# UNITED STATES PATENT AND TRADEMARK OFFICE

APPLICATION NO.	FILING DATE	FIRST NAMED INVENTOR	ATTORNEY DOCKET NO.	CONFIRMATION NO.
10/525,030	10/14/2005	Millind Diwakar Atrey	038871.55852US	3490
23911 7590 01/23/2008 CROWELL & MORING LLP INTELLECTUAL PROPERTY GROUP P.O. BOX 14300 WASHINGTON, DC 20044-4300				
EXAMINER				
KASTURE, DNYANESH G				
ART UNIT		PAPER NUMBER		
4147				
MAIL DATE		DELIVERY MODE		
01/23/2008		PAPER

# Office Action Summary

FIG. 4

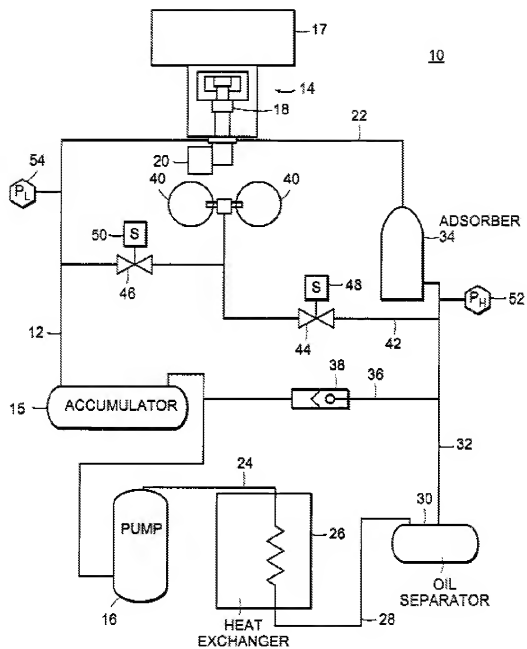
10. In Re claim 1, with reference to Figure 4 above, Morse et al discloses a pumped helium circuit (column 3, lines 25-29) comprising:

- a compressor (16)
- high pressure port which is inherent to the compressor pump outlet
- low pressure port which is inherent to the compressor pump inlet
- supplied equipment (17)
- compressed helium is supplied through line (22) and returns from line (12)
- a pressure relief valve (38) which opens in response to a predetermined pressure differential linking the high and low pressure ports as stated in column 3, lines 55-60: "When the pressure of the helium within the supply line 32 reaches a certain

point beyond the pressure necessary to overcome the bias against the valve, the valve opens to allow helium to flow from the helium supply line to the helium return line 12..”

- With regards to “means for preventing oil carry-over from the compressor to the supplied equipment, characterized in that said means comprises means for preventing oil leaving the low pressure port and traveling towards the supplied equipment” within claim 1, this limitation meets the three prong test per MPEP 2181 and thereby invokes 35 USC 112 6<sup>th</sup> paragraph. The means for preventing oil carry-over from the compressor to the supplied equipment has been disclosed in the specification as an oil trap or an oil adsorber which prevents oil from leaving the low pressure port and travels towards the supplied equipment. Morse et al discloses an accumulator (15) which provides a “Buffer” as stated in column 3, line 31. The accumulator (15) is therefore the corresponding element for an oil trap or oil adsorber.

11. However, Morse et al does not disclose a non-return valve located between a low pressure side of the pressure relief valve and the supplied equipment.

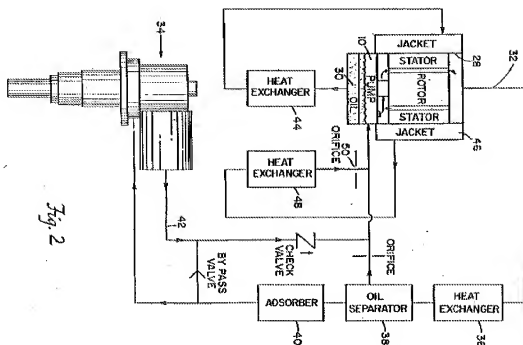
12. Nevertheless, Klusmier discloses a cryogenic refrigeration system comprising a “Check Valve” in Figure 2 depicted above, which is a non return valve.

13. It would have been obvious to a person having ordinary skill in the art at the time of the invention to modify the pumped helium circuit of Morse et al to incorporate the check valve of Klusmier in the helium circuit between a low pressure side of the pressure relief valve and the supplied equipment for the purpose of separating the oil from the mixture as stated in column 1, lines 13-14 of Klusmier.

FIG. 2

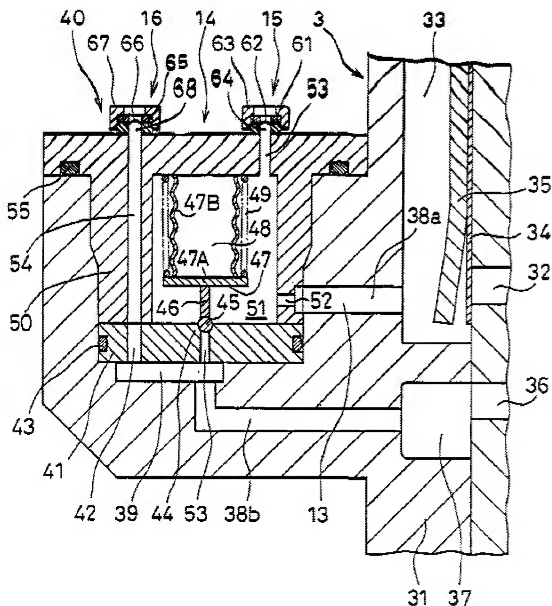
25. Nevertheless, in Figure 2 depicted above, Kanai et al discloses a valve element (45) between the bypass passage (38a) (originating at the high pressure side) and bypass passage (38b) inside the compressor. The valve (45) is operable to return compressed helium from the high pressure port back to the compressor through internal bypass passages (38a) and (38b) in response to a predetermined pressure differential.

26. It would have been obvious to a person having ordinary skill in the art at the time of the invention to modify the compressor disclosed by Morse et al to include the valve element and bypass passage configuration of Kanai et al for the purpose of "safety,
